**No. 97-9**

**NOTICE: The information contained in this Service Bulletin supersedes all previous bulletins, including 93-14.**

## Weber 4 bbl Carburetor

### 4.3 LX Flame Arrestor Stud Breakage or Cracked Air Horn, S/N 0F001219 and Below

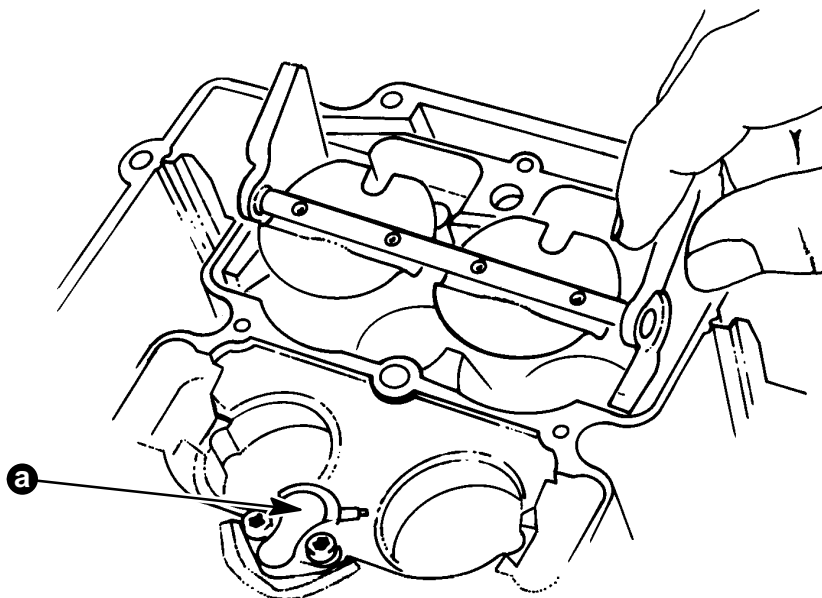
If you experience this condition, order the following parts to correct the problem.

**NOTE:** The replacement stud will not thread in by hand because it has an interference thread on it. You must use a stud driver to install it.

16-805277 Stud

3310-818660A1 Air Horn. Replace only if it is cracked or you cannot get the broken stud out.

### Performance Problems on MCM 7.4L Sterndrive Engine, S/N 0F022828 and Below or MIE 7.4L Inboard, S/N 0D857999 and Below

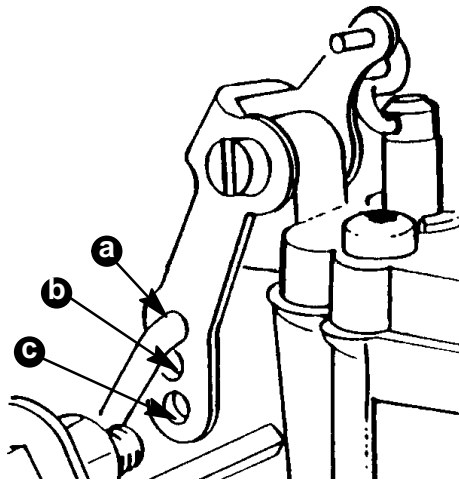
- a. Engine runs rich at idle.
- b. Engine has a backfire between 2400 and 2600 RPM.
- c. Engine has a surge above 4000 RPM.

Check the jet sizes in the carburetor. The main jets should be .107 in. and the secondary jets should be .098 in. If they are not, change them. Engines above the serial numbers listed have these jets already in their carburetors.

811541 Main Jet, .107 in.

811542 Secondary Jet, .098 in.
